ENGINE COMPONENTS, INC.

S.I. No.: 02-2

**Title: CRANKCASE THRUST WASHER MODIFICATION**

CRANKCASE WITH THRUST WASHER MODIFICATION

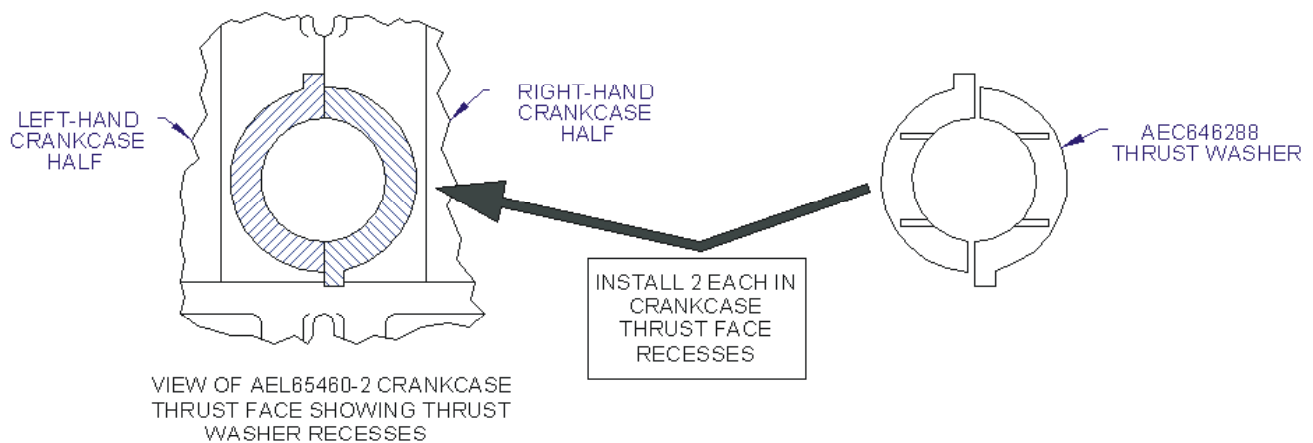
- 4.0 **PROCEDURE:** Crankcases with thrust washer modification (AEL65460-2, AEL65460-4, AEL65460-6, AEL65460-8, AEL65460-10, and AEL65460-12) must have AEC646288 (or equivalent approved replacement) installed in order to meet clearance requirements. Thrust washers shall be installed as indicated below, with the scallops/oil relief grooves facing towards the crankshaft.
